Reference: GC Estates Addition, Preliminary Plan

We have revised the Preliminary Plan as per your comments dated 6-27-2022. Our responses are below

Preliminary Development Plan Review

(GC Estates Addition)

468TH AVE DRAINAGE OVERVIEW
 CITY OF TEA, SOUTH DAKOTA
 EXHIBIT 1

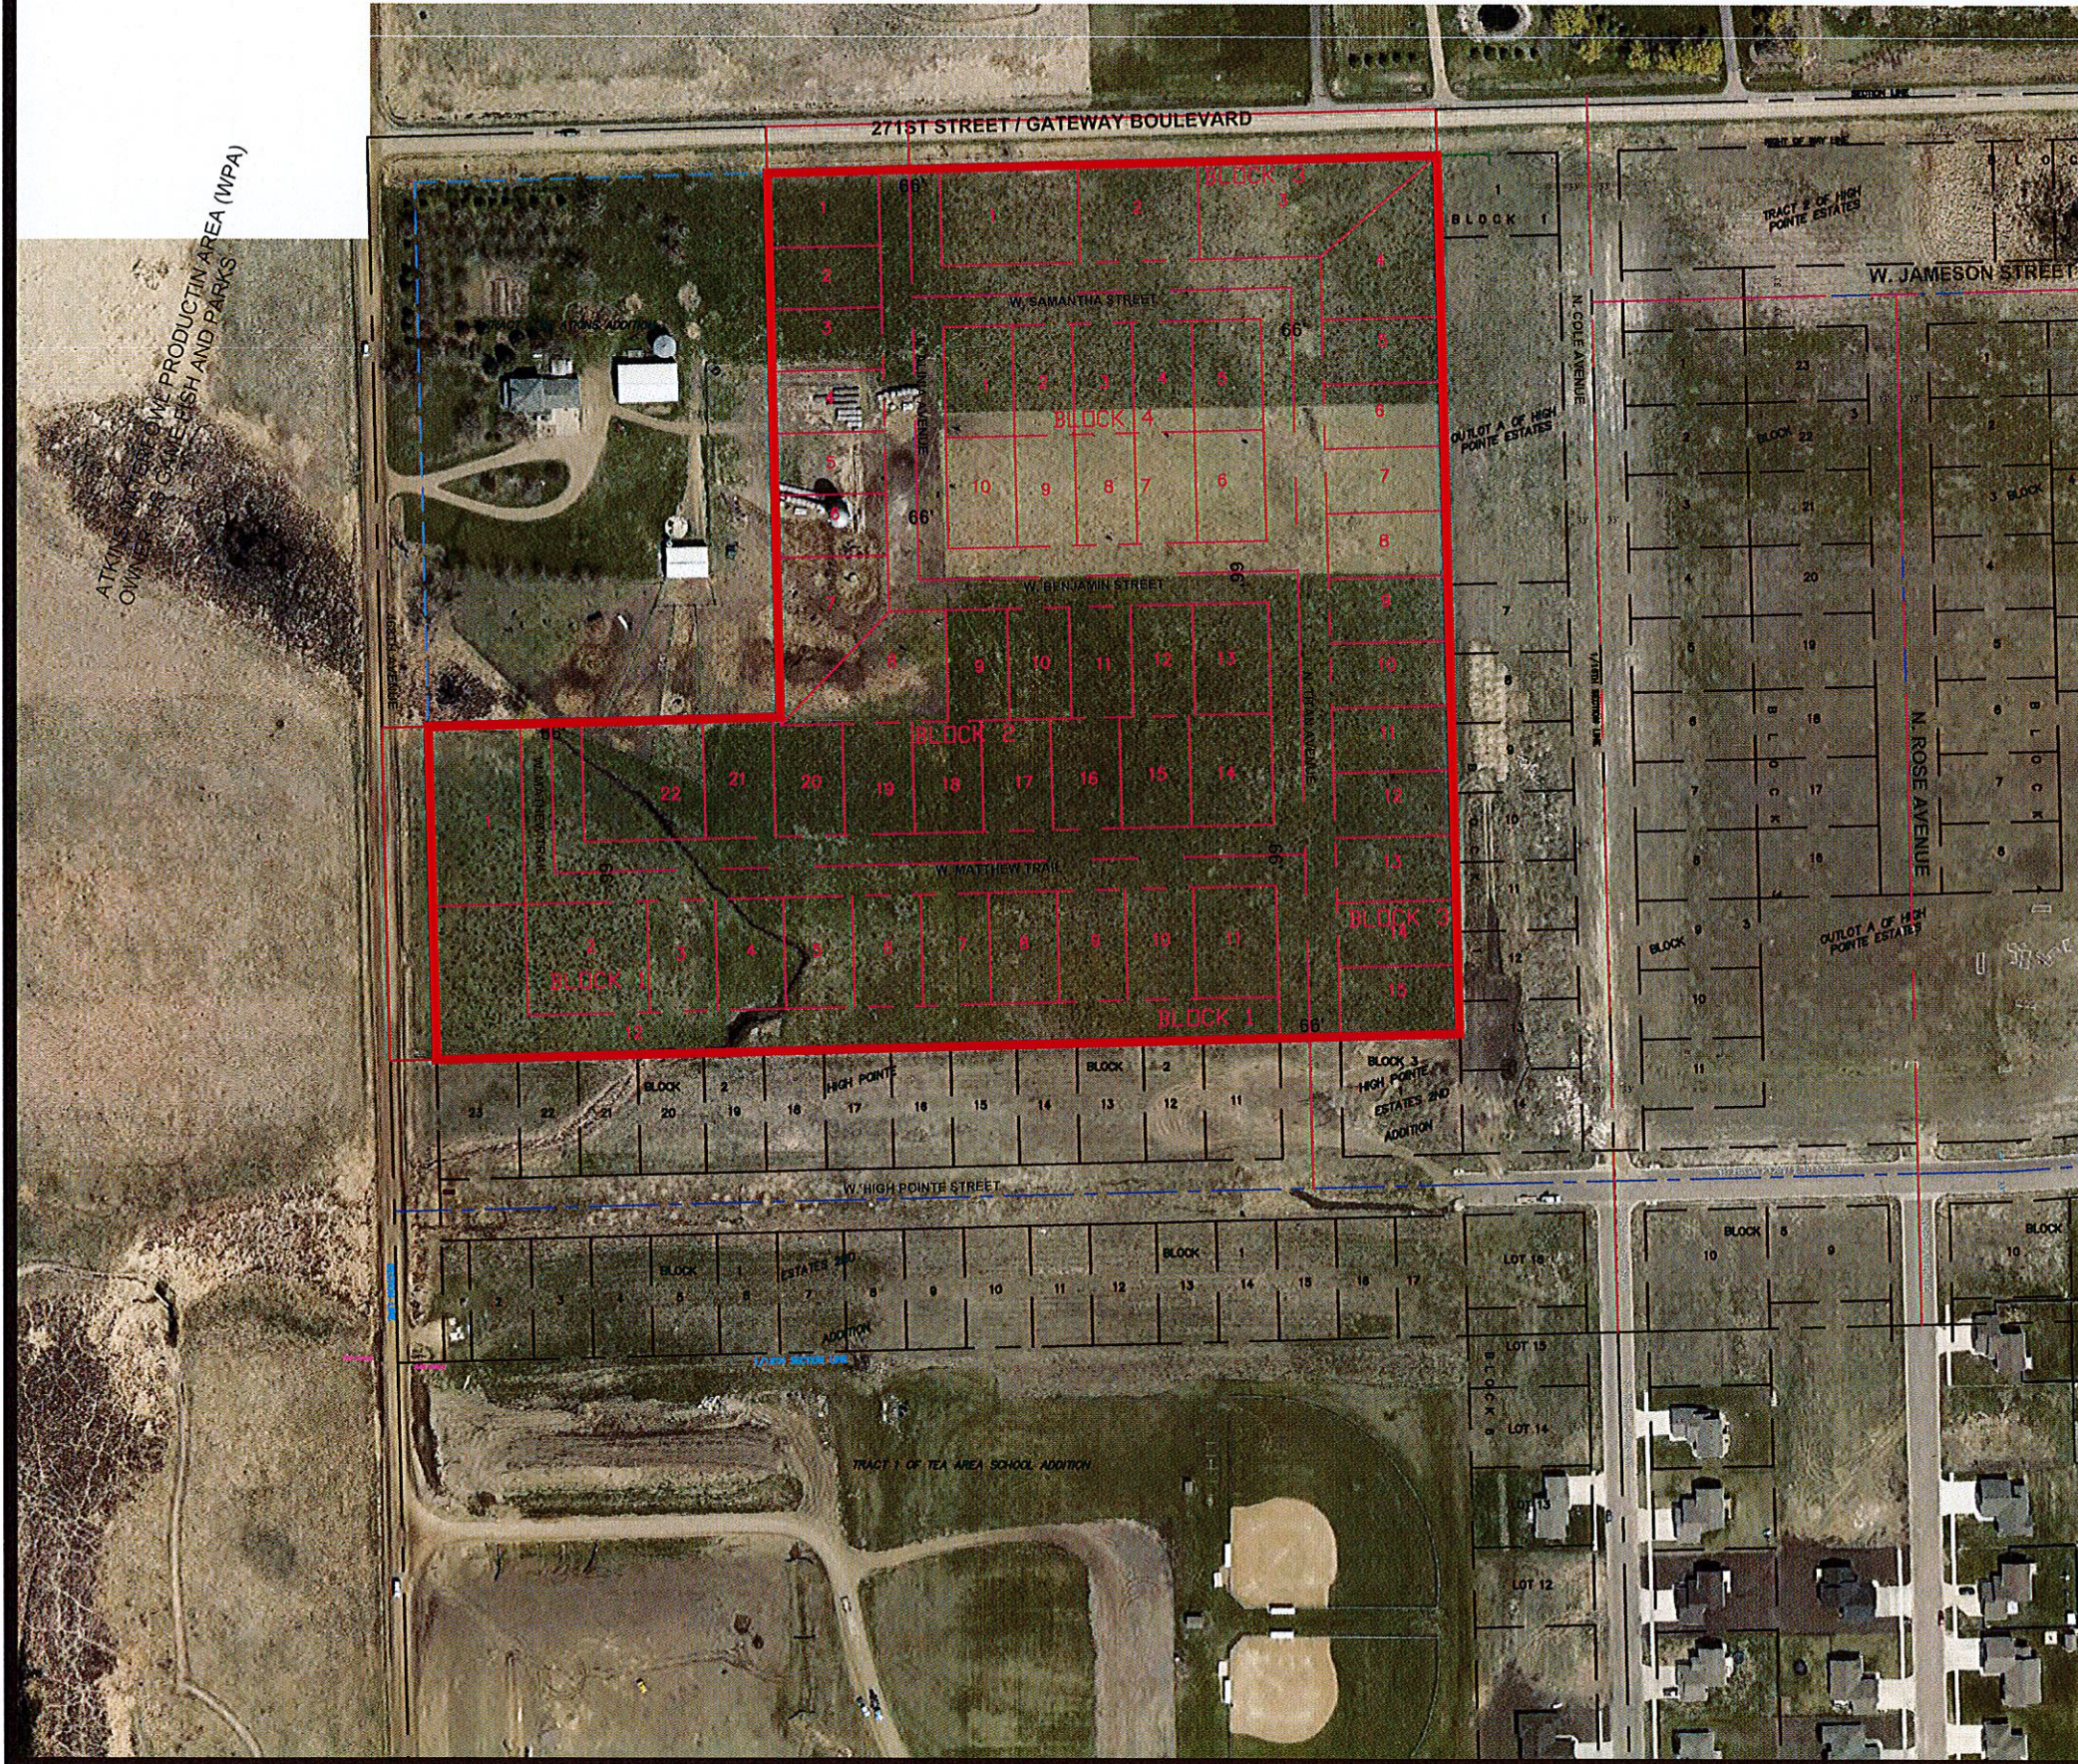
Comments **Refer to previous comments shared by Ben Scholtz via E-mail on 6/21/22. Also refer to attached exhibit prepared by HDR that illustrates the majority of the contributing drainage basin surrounding this subdivision area for reference only.**

ZONING AND PHASING

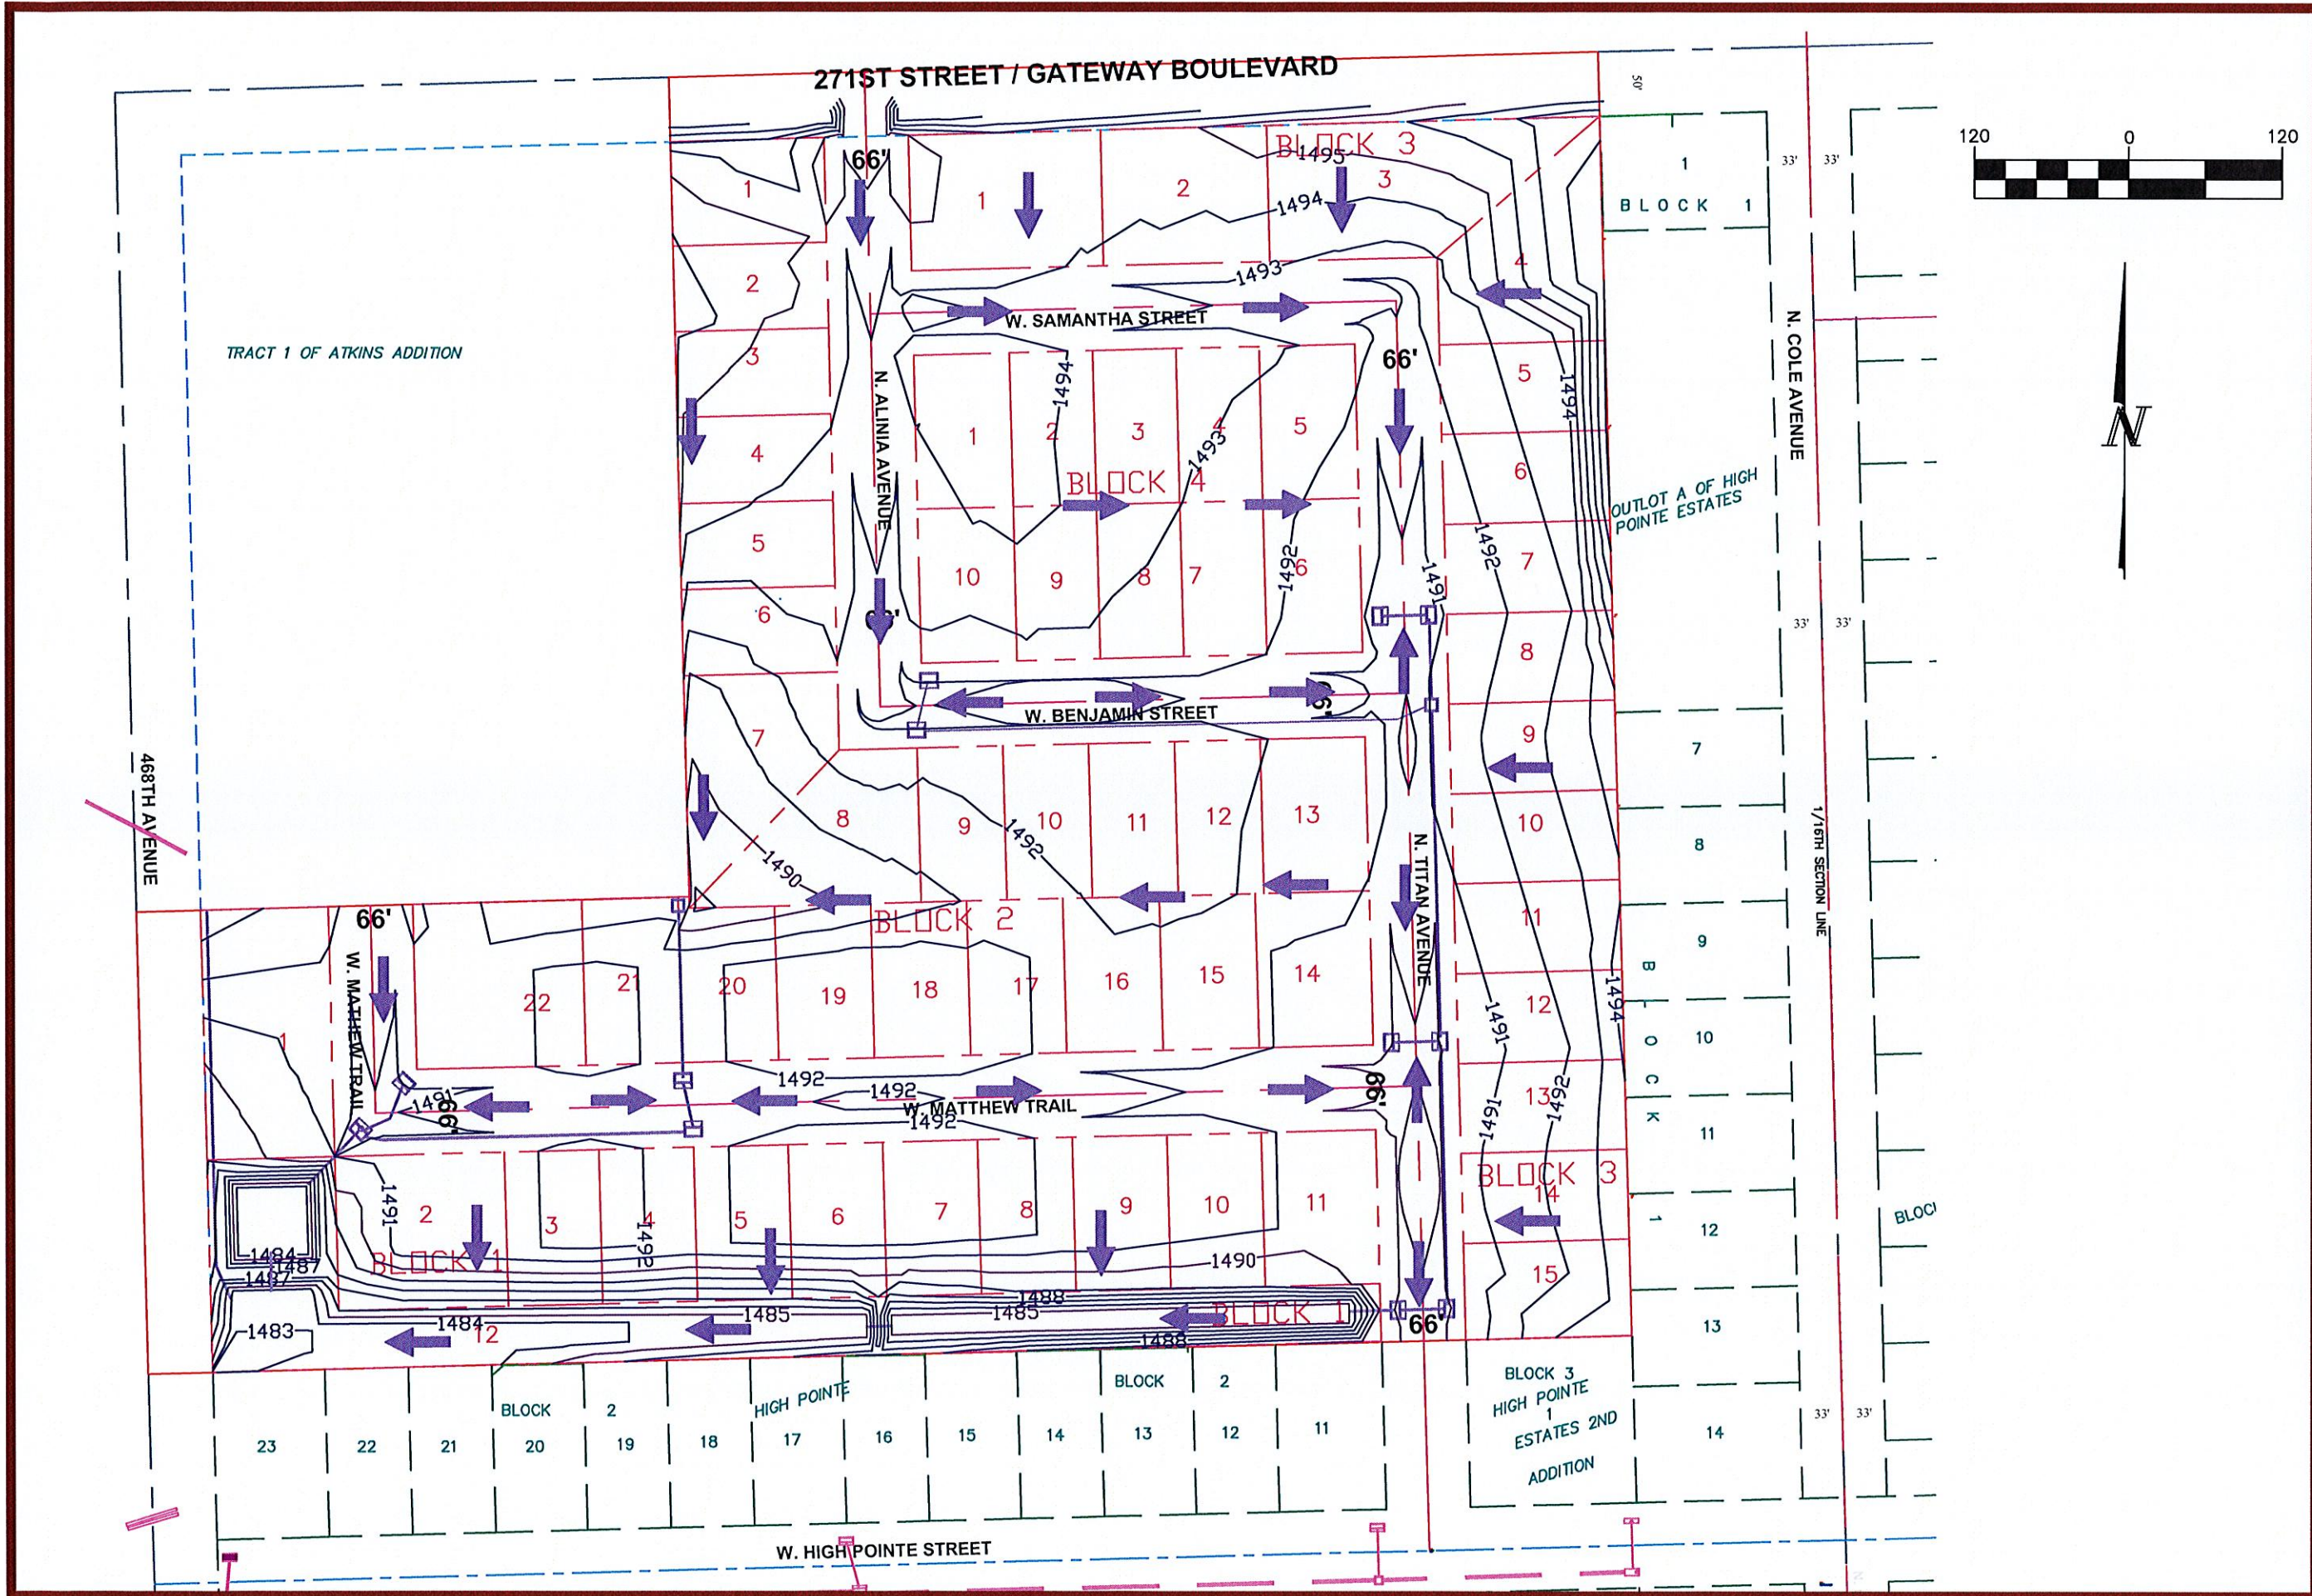
4. Please include zoning - **Added**
5. Please include Street ROWs - **Added**
6. Please include street light layout.
7. Please include existing culverts. - **Added**

23. Please include phasing schedule – **Added**

GRADING PLAN
 PRELIMINARY PLAN
 GC ESTATES ADDITION

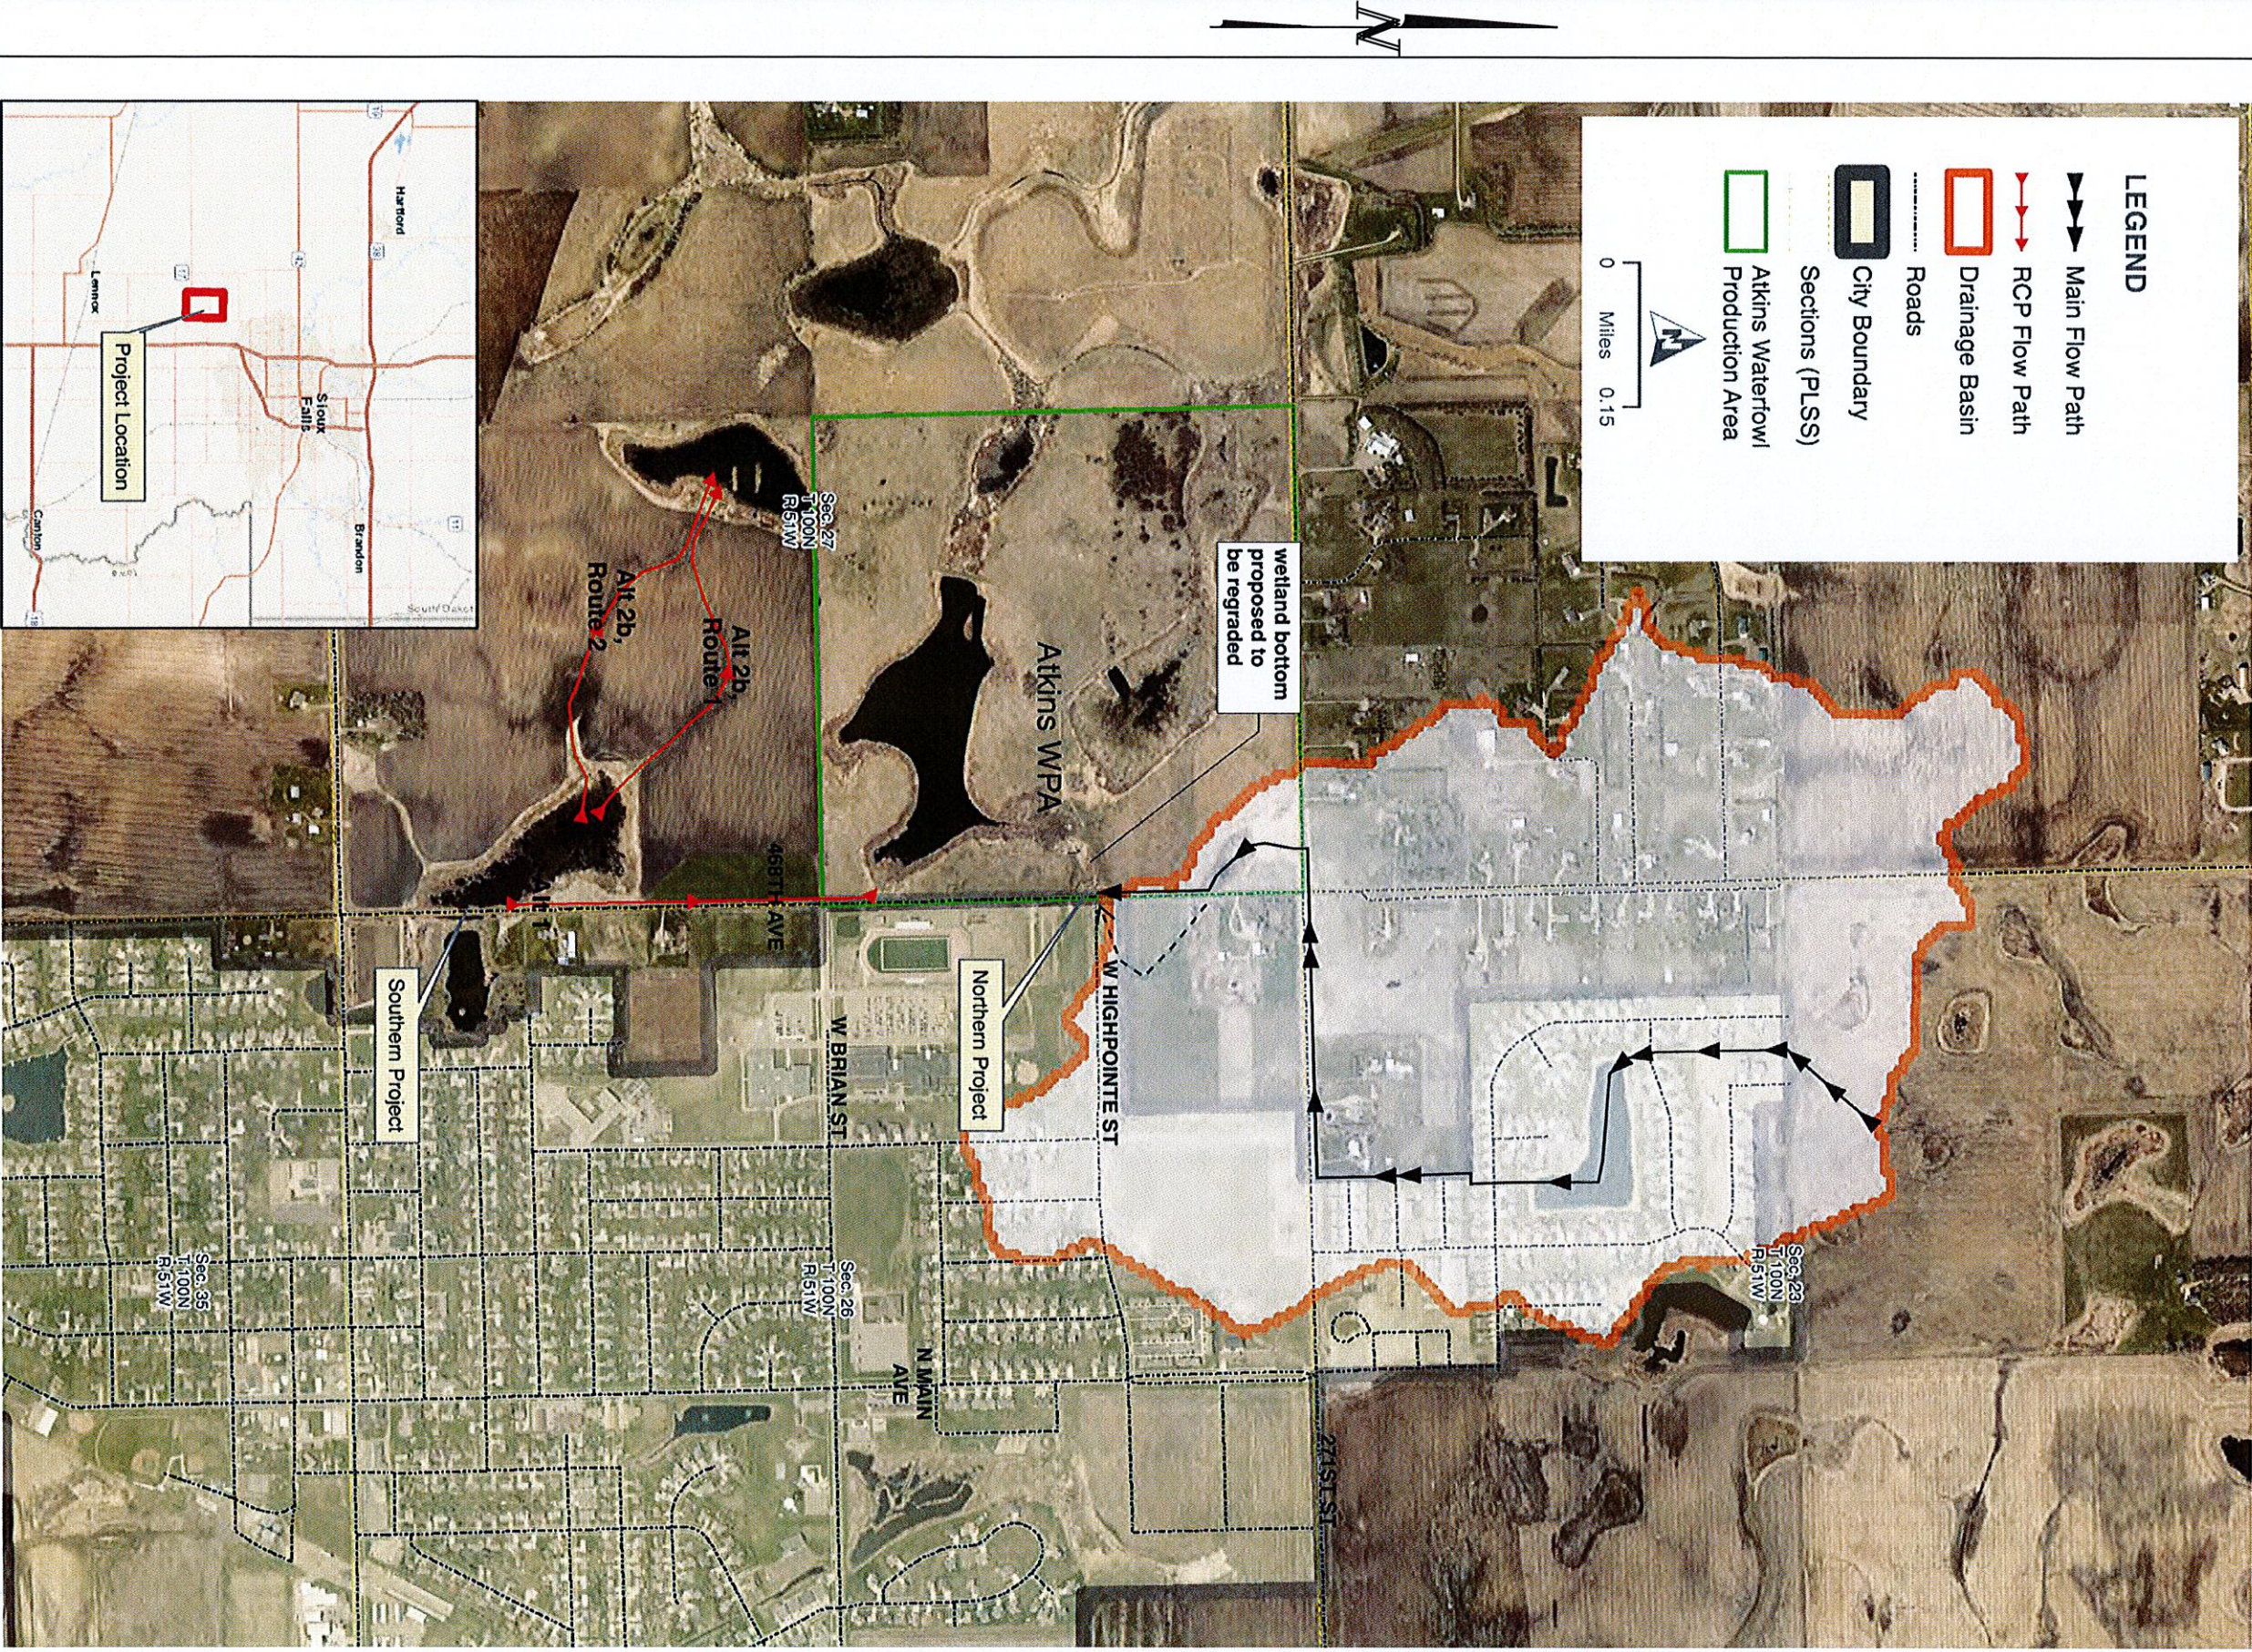
11. Please remove all the existing contours in the background of the Grading plan (sheet 3) - I'm not a fan of showing all the existing and proposed stuff on the same sheet, it's confusing and distracting. - **Removed**
